ECK 9TH ADDITION SEDGWICK COUNTY, KANSAS

RE: SUB 2001-68 -- Final Plat of Eck Ninth Addition

At the regular meeting of the Subdivision Committee of the Metropolitan Area Planning Commission on Thursday, August 30, 2001, the above captioned plat was considered. The action of the Committee was to approve the final plat, subject to the following:

CASE NUMBER: SUB 2001-68 -- ECK NINTH ADDITION

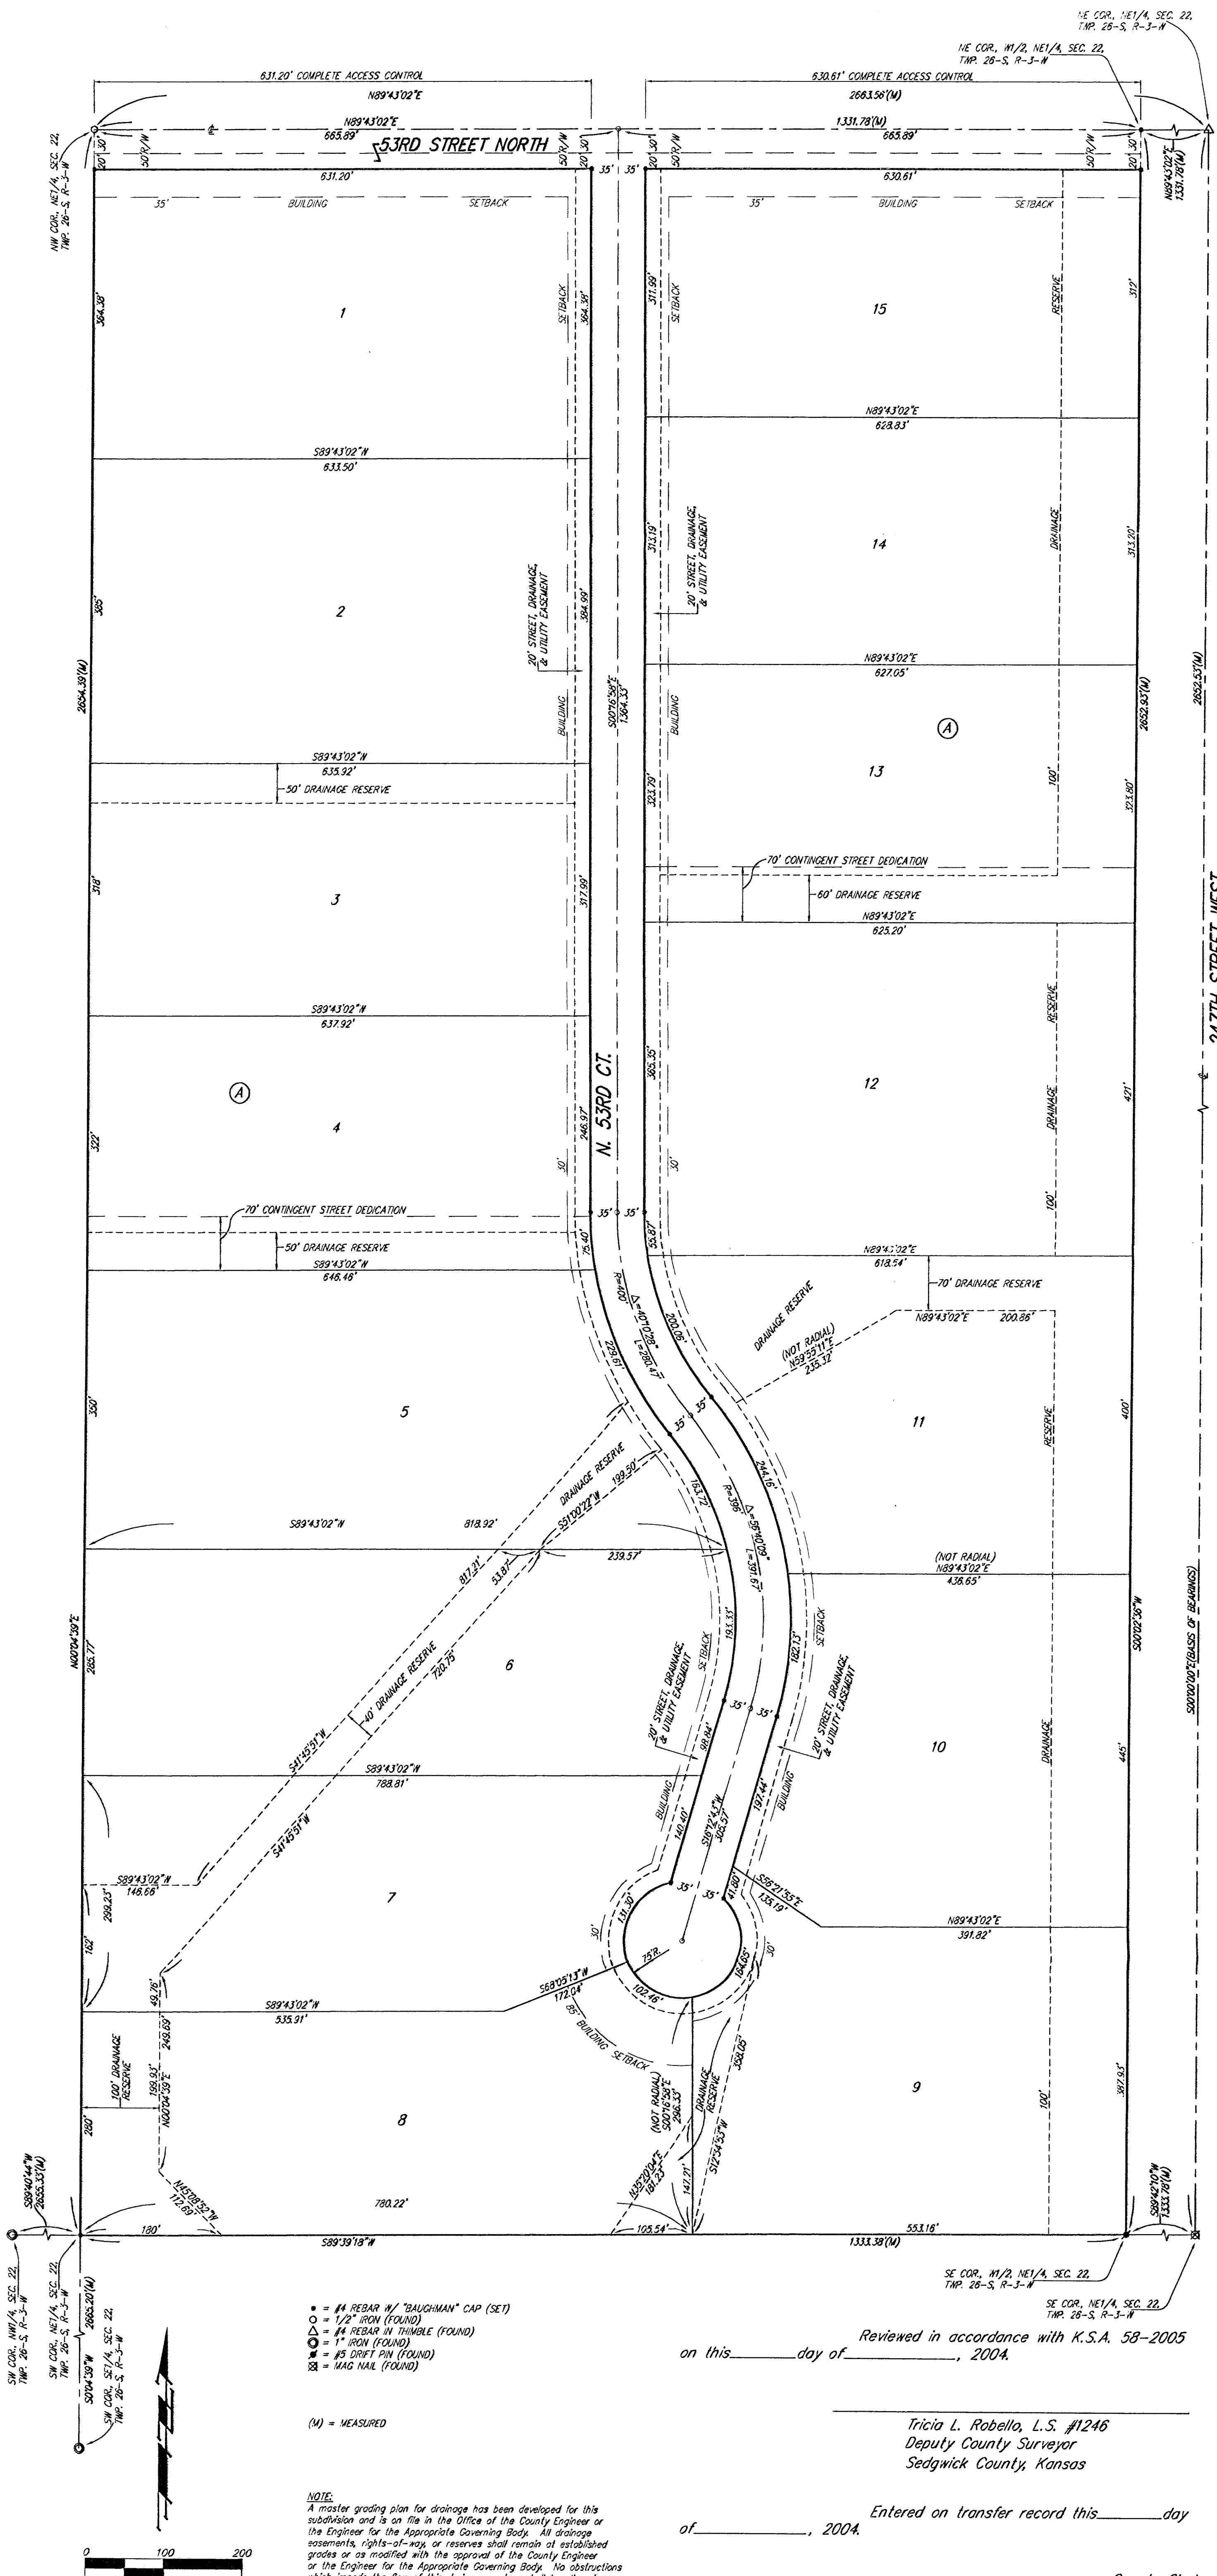
- A. Since neither municipal water nor sanitary sewer is available to serve this property, the applicant shall contact the Environmental Health Division of the Health Department to find out what tests may be necessary and what standards are to be met for approval of on-site sewerage facilities and water wells. A memorandum shall be obtained specifying approval. An updated layout denoting drainage reserves needs to be provided.

- C. County Engineering needs to comment on the status of the applicant's drainage plan. A detailed final drainage plan is needed and additional drainage reserves are required. A lot grading plan is also needed.

- D. County Fire Department needs to comment on the street length of 53rd St. . Ct., which is 2,100 feet exceeding the 1,200-ft limitation of the Subdivision Regulations. The street length is approved contingent upon the installation of a 36-ft wide rock road and contingent street right-of-way dedication to the east and west. The Subdivision Committee has approved a modification.

- F. County Engineering has required a 70-ft contingent dedication of street right-of-way extending to the east and west line of the plat in order to provide potential street connection to adjoining properties. The plat's text needs to be revised to reference Lots 3, 4, 13 and 14, Block A.
- G. The County Fire Department needs to comment on the plat's street names. *The street name needs to be revised to N. 53rd Ct.*

- H. The Applicant has indicated a blanket pipeline easement for the area involved in this plat. The Applicant shall either obtain a release of this easement or provide proof that the easement has been confined. If confined, any portion of this easement impacting this site shall be denoted on the plat and shall be properly referenced. A recorded copy of the release/confinement of the easement shall be submitted.

- I. Lots 8 and 9 have been platted with increased setbacks in order to conform with the 200-ft lot width standard which is measured at the building setback line.

- J. The plat's text shall include language that a drainage plan has been developed for the plat and that all drainage easements, rights-of-way, or reserves shall remain at established grades or as modified with the approval of the applicable City or County Engineer, and unobstructed to allow for the conveyance of stormwater.

The requested street name has been platted.
